ADDENDUM 01

July 24, 2026

Bradford Exempted Village Schools
New Athletic Facility
760 Railroad Avenue
Bradford, OH 45308

LPA PROJECT NO. 263401.00

26 WEST ELEVATION - ALTERNATE

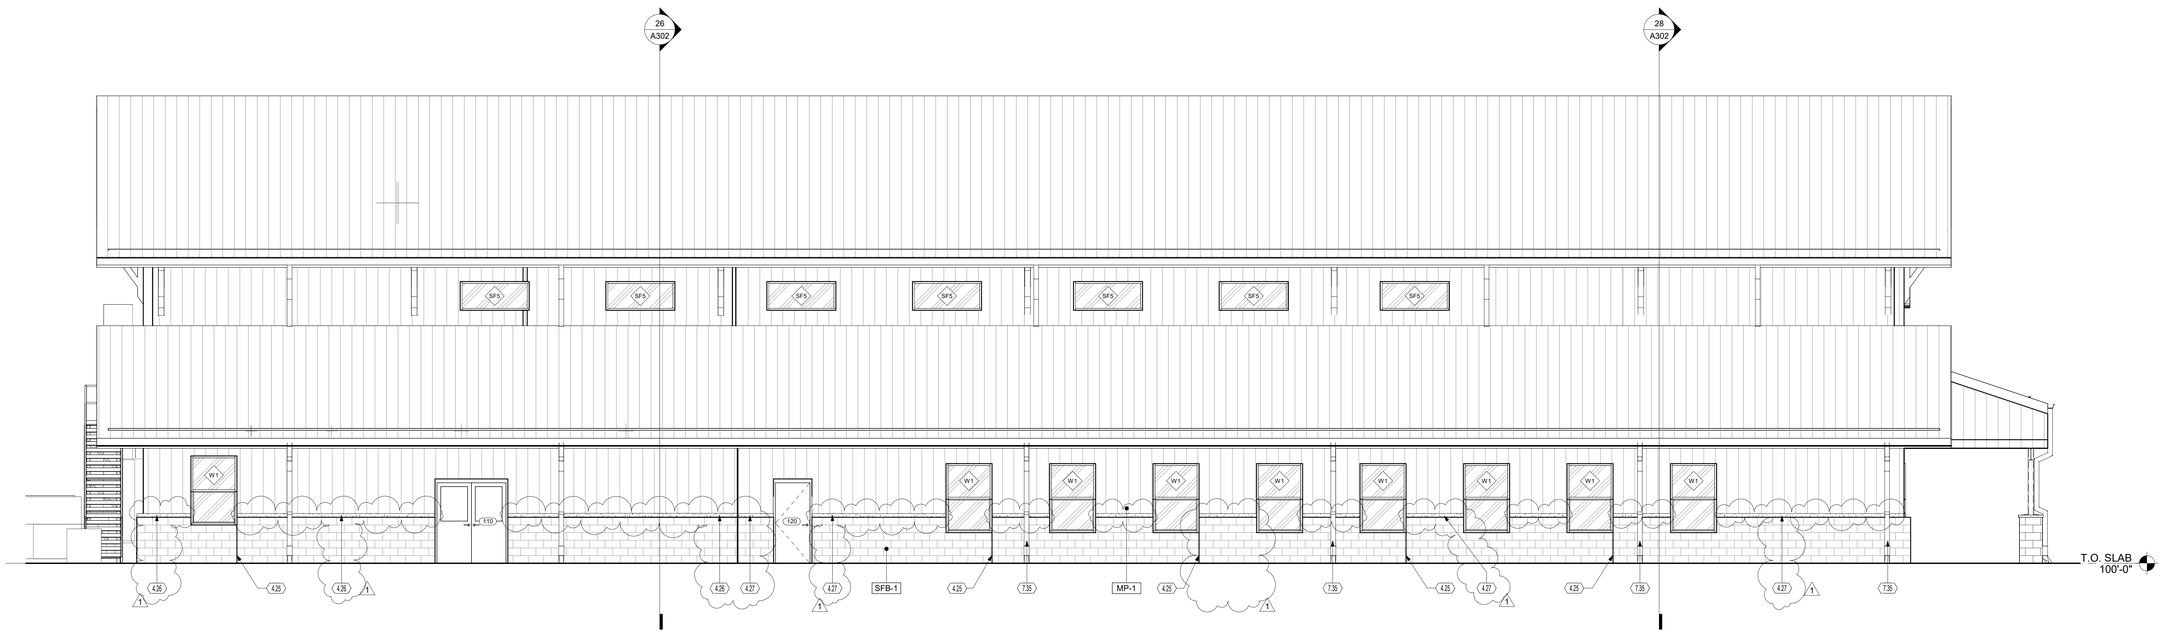
2.10 Sheet A203 – EXTERIOR ELEVATIONS.

2.10.1 Added alternate limestone water table at the CMU wainscot.

2.10.2 Deleted keynotes for the metal panel siding and added material designations for clarity.

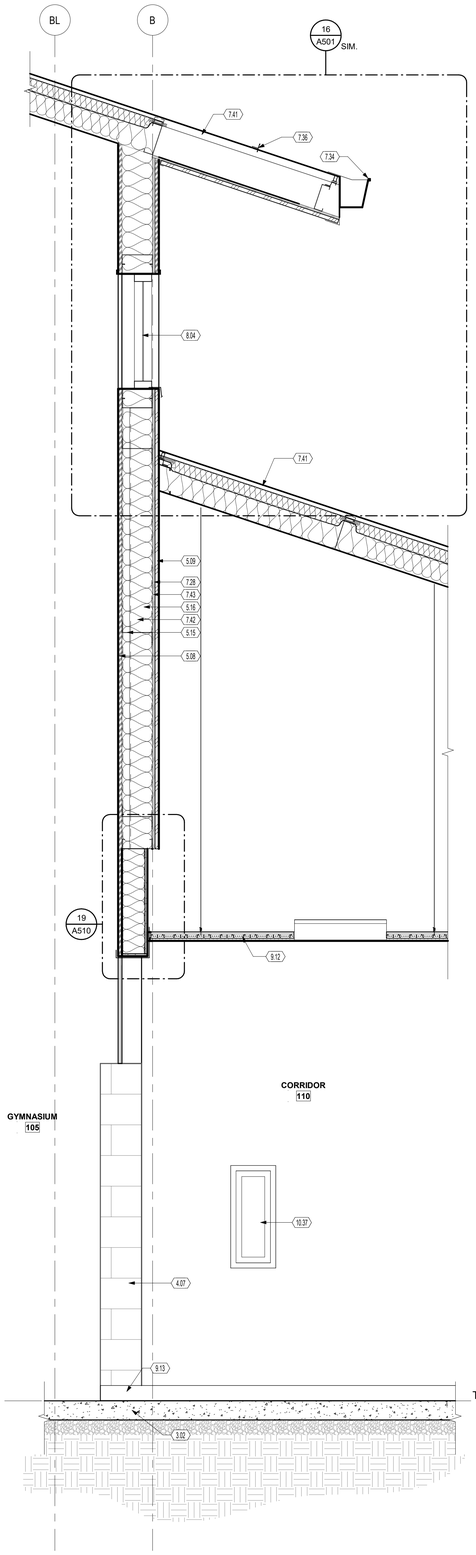
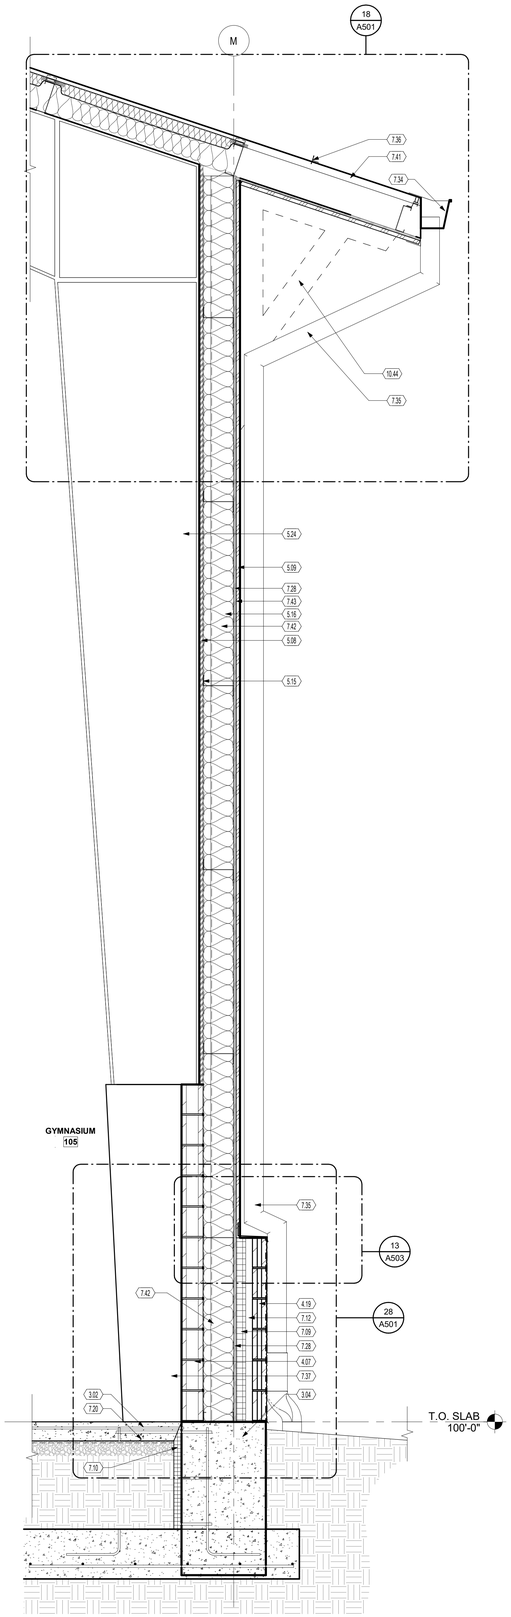
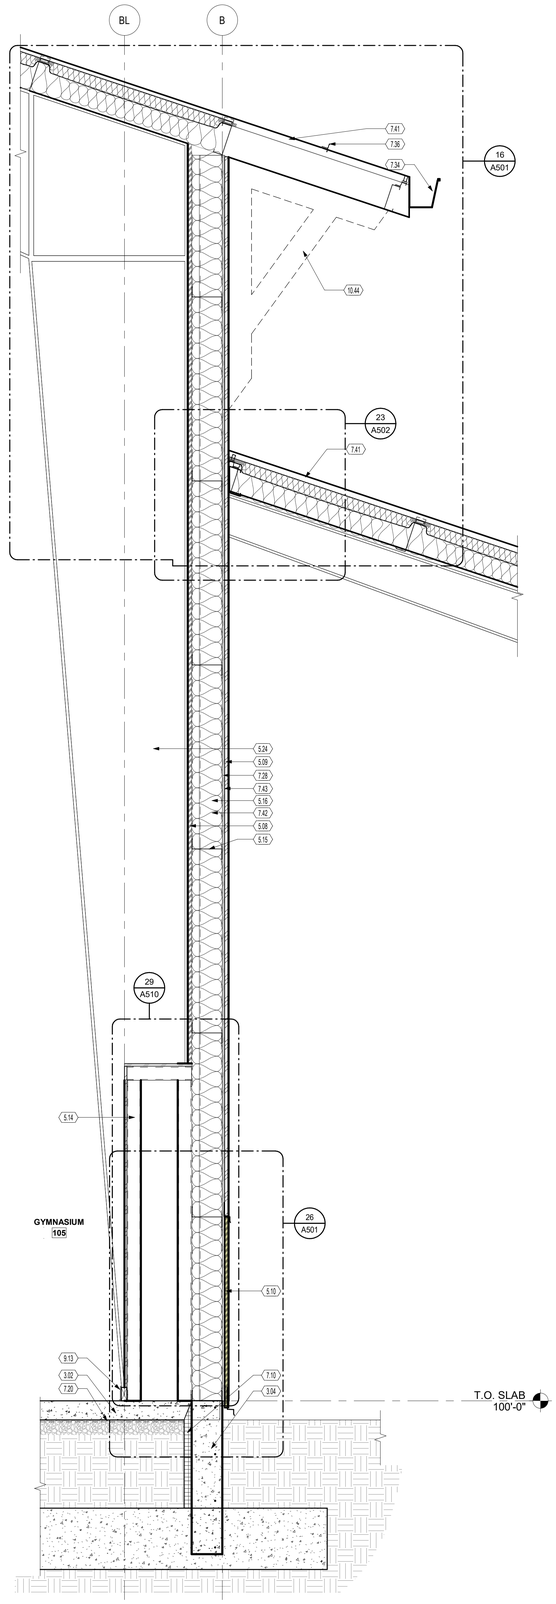
2.11 Sheet A310 – WALL SECTIONS.

2.11.1 Revised keynote 5.08 clarifying that the gym liner panel is Alternate G-5.

2.11.2 Revised keynotes 5.09 and 5.10 to indicate metal panel siding for the exterior.

2.11.3 Revised plywood substrate in the Wall Assembly R-Values to 5/8” matching the sections and details.

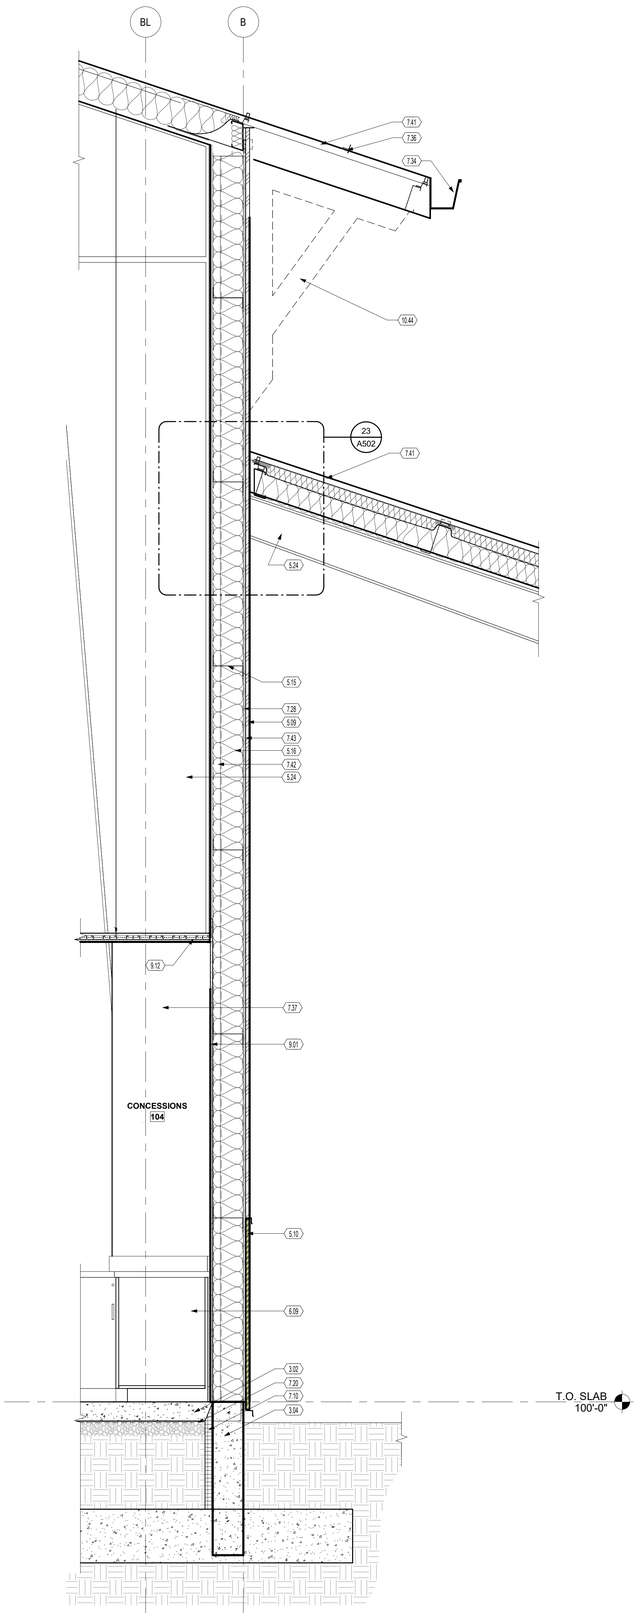
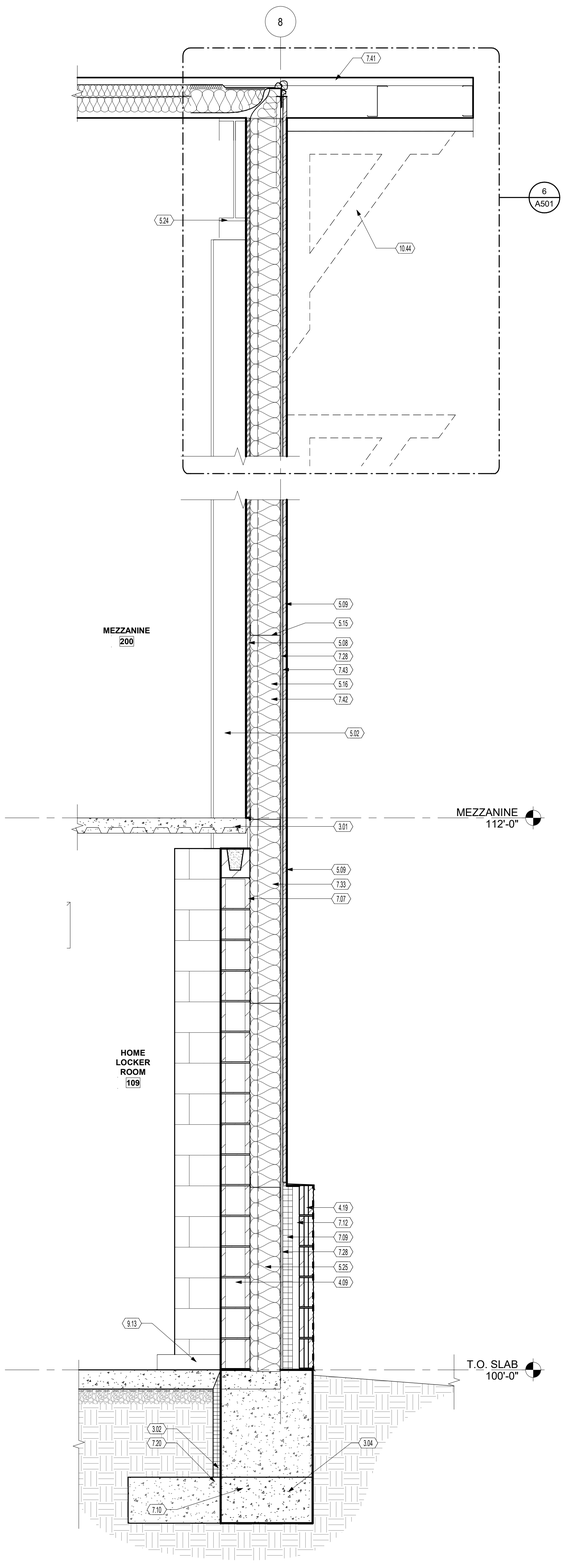
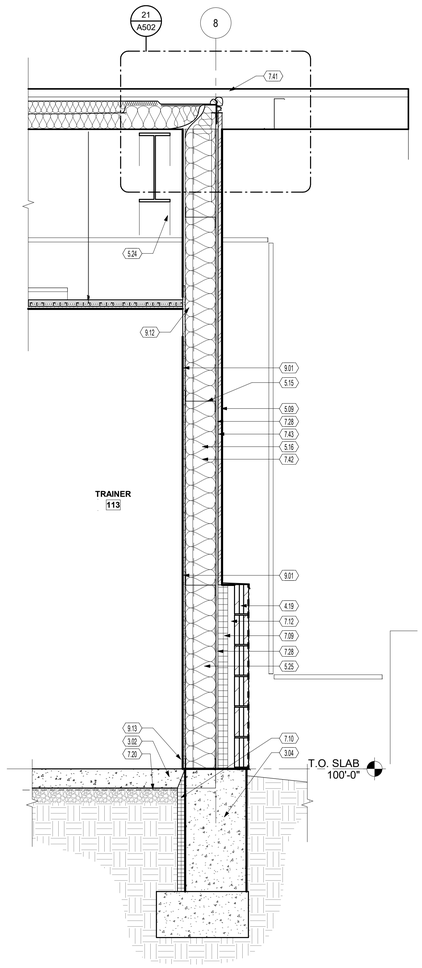
2.12 Sheet A311 – WALL SECTIONS.

2.12.1 Revised keynote 5.08 clarifying that the gym liner panel is Alternate G-5.

2.12.2 Revised keynotes 5.09 and 5.10 to indicate metal panel siding for the exterior.

2.12.3 Revised plywood substrate in the Wall Assembly R-Values to 5/8” matching the sections and details.

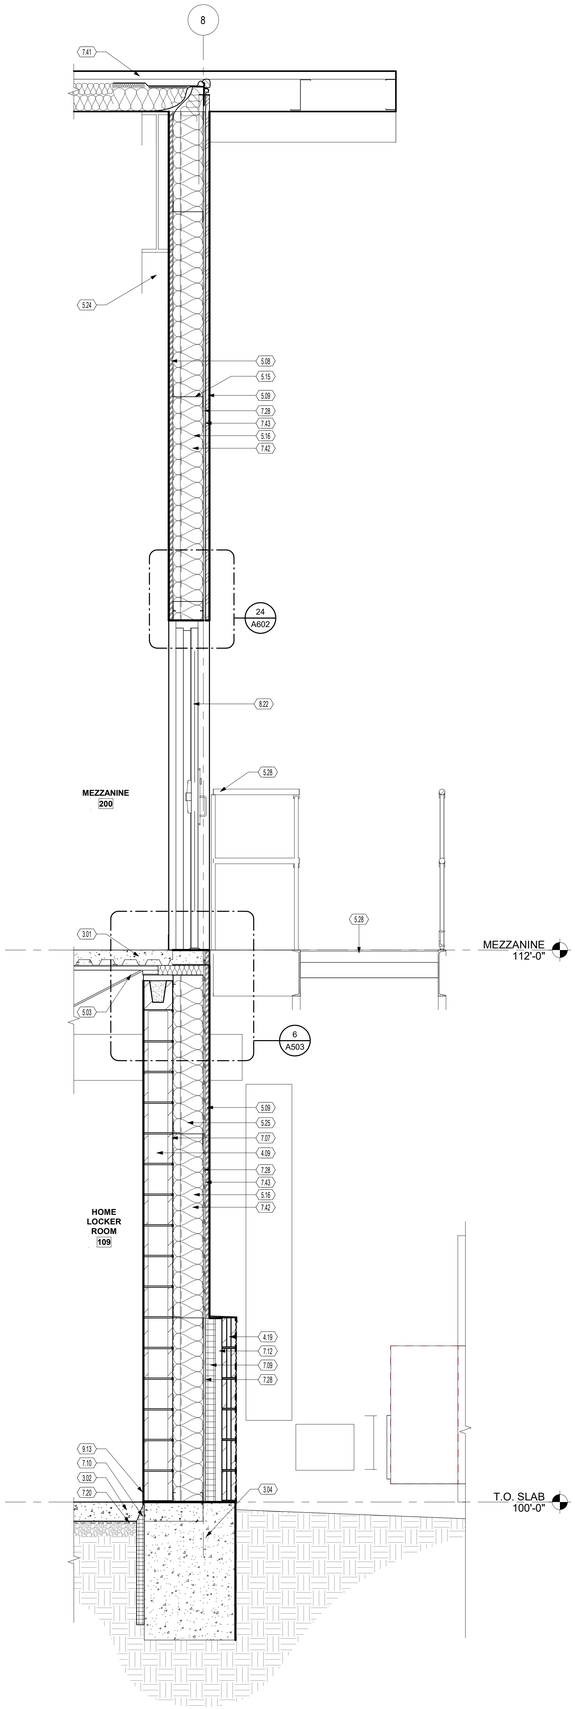
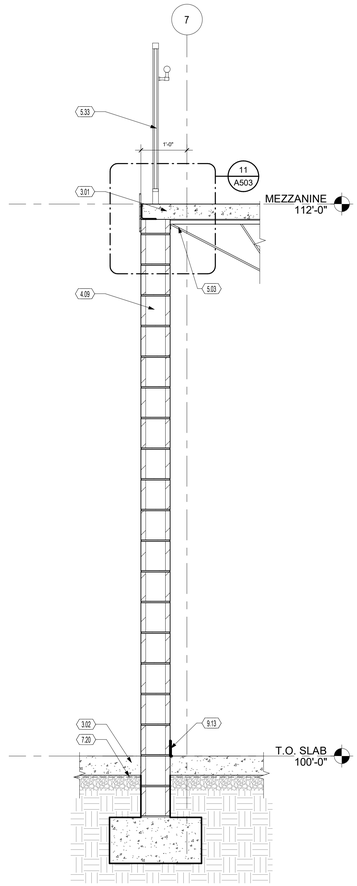
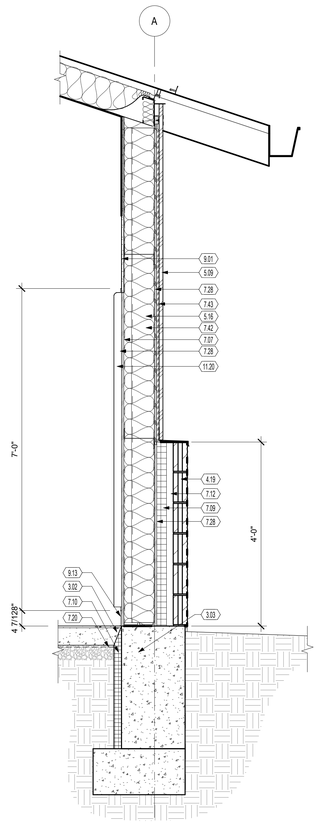
2.13 Sheet A312 – WALL SECTIONS.

2.13.1 Revised keynote 5.08 clarifying that the gym liner panel is Alternate G-5.

2.13.2 Revised keynote 5.09 to indicate metal panel siding for the exterior.

2.13.3 Revised plywood substrate in the Wall Assembly R-Values to 5/8" matching the sections and details

26 VISITOR LOCKER ROOM ENLARGED FLOOR PLAN
SCALE | 1/2" = 1'-0"

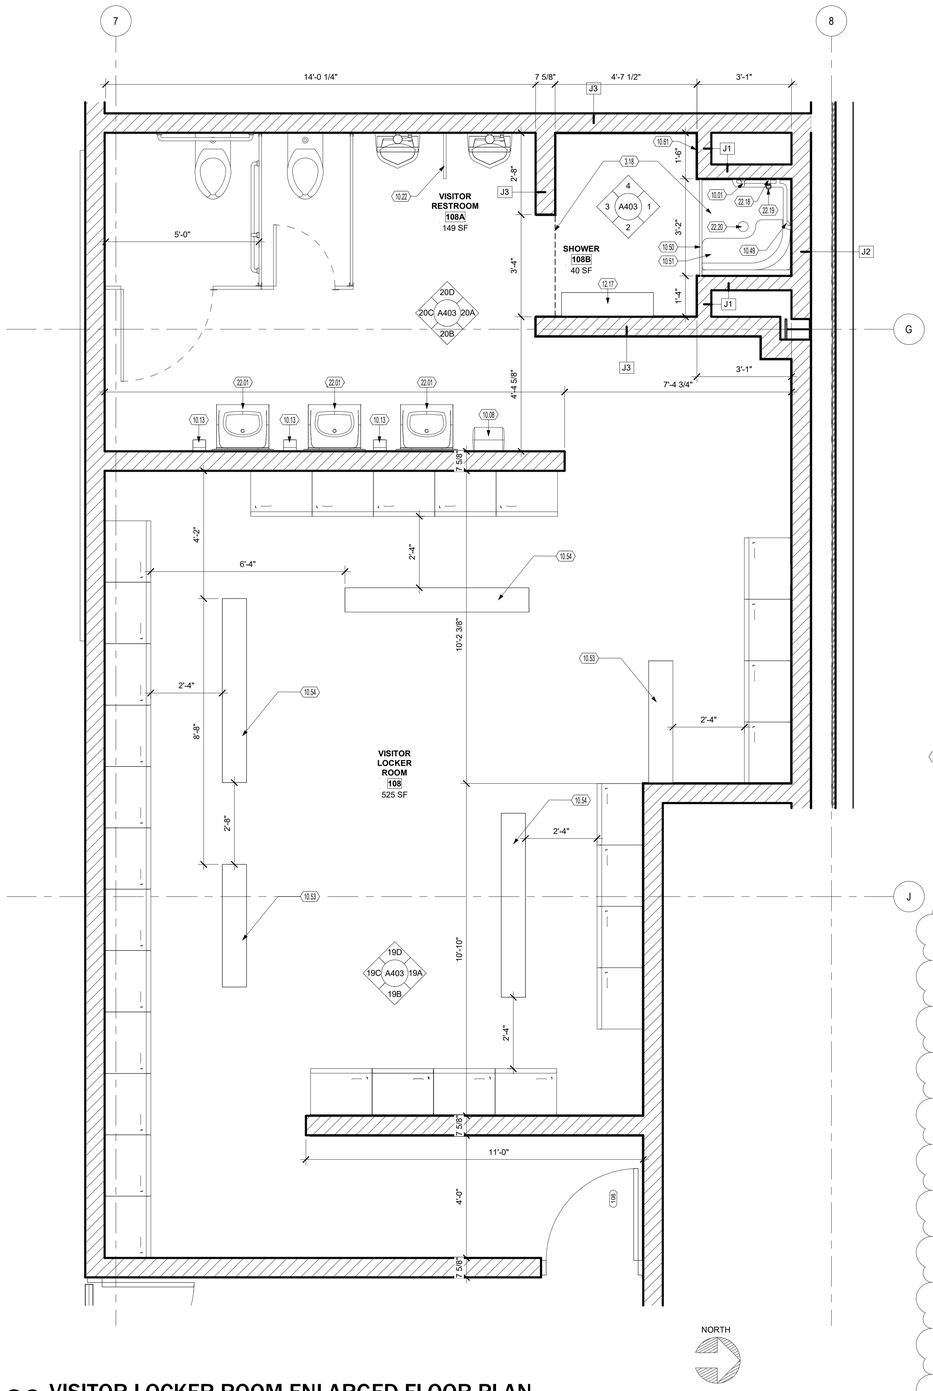
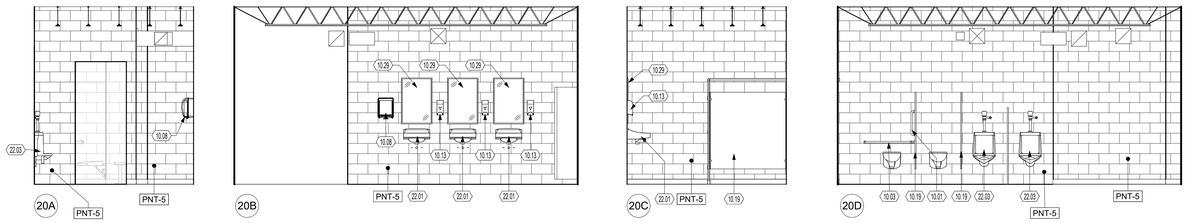
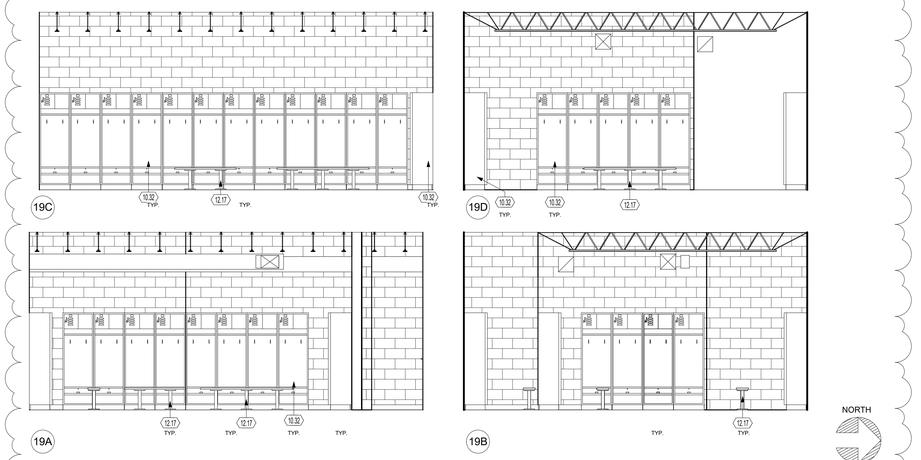
2.15 Sheet A403 – RESTROOM PLANS AND ELEVATIONS.

2.15.1 Added basis of design diaper changing station to RR ACCESSORY SCHEDULE.

2.15.2 Added basis of design mirror to RR ACCESSORY SCHEDULE.

2.15.3 Revised note 10.32 adding a 14 gauge metal base provided by the locker manufacturer. Indicated base on the interior elevations.
